BMP NUMBER: SC022

**James City County Environmental Division
Stormwater Management / BMP Inspection Report
Detention and Retention Pond Facilities**

County BMP ID Code (if known): 50022
 Name of Facility: Walmart Phase 3 BMP No.: 3 of 6 Date: 12-2-05
 Location: Pond H, south central portion of site (near Pond G)
 Name of Owner: Walmart
 Name of Inspector: SJ Thomas
 Type of Facility: wet ext Det Pond
 Weather Conditions: Sunny Cold 50's Type: Final Inspection County BMP Inspection Program Owner Inspection

BMP FINAL INSPECTIONS

POUD H FIELD ITEMS

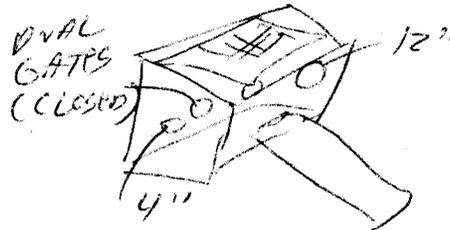
- need constant
- need sealed AB
- Remove SF & ORANGE SAFETY FRAME AT BARREL OUTFALL + West end of dam
- Remove Jrg from Headwall at 15' barrel outfall end.
-

- NPWL is higher than Pond E+6. COVERING BARREL 2-4"
- No signs of barrel piping.
